Program Bulletin

CUSTOMER SATISFACTION PROGRAM

SUBJECT: Front Strut - Noise

MODELS: 2012-2013 Chevrolet Colorado

Figure 1

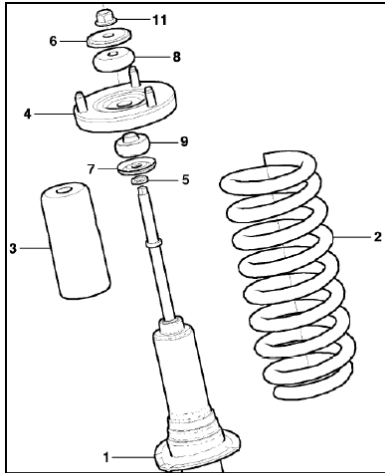
3. Before removing the top mount bracket (refer figure 1, item 4), place alignment marks on the top mount bracket and spring using the outboard mounting bolt on the strut top bracket as a reference. Mark the bottom of the spring to shocker absorber as well. These marks should all be aligned as shown in figure 2 and 3.

4. Remove the top mount plate. Ensure SI procedures are followed as the spring is under tension and injury could occur if incorrectly disassembled.
5. Refer to figure 1 - the lower bush (9) will be replaced as well as the spring seat isolator (not shown in figure 1). In addition, inspect the top mount bracket (4), cup washer (7), upper bush (8), and shocker absorber rod (1) for damage. Follow these guidelines to determine if these parts should be replaced:
 - Place a straight edge along the shocker absorber rod as shown in figure 4.
 - Measure the depth of wear on the shaft. If the wear is greater than 1mm, replace the shock absorber.
 - Inspect the steel washer (silver) that is pressed into the centre of the top mount bracket. If the washer has worn through to the black steel mount bracket, then replace the top mount bracket, refer figure 5.

- Inspect the upper bush (8), if the bush is out of shape or is damaged, replace the bush. In most cases it is expected that the upper bush can be reused. Do not replace it unless necessary.
- Inspect the cup washer (7) for distortion or other damage. Replace only if required.
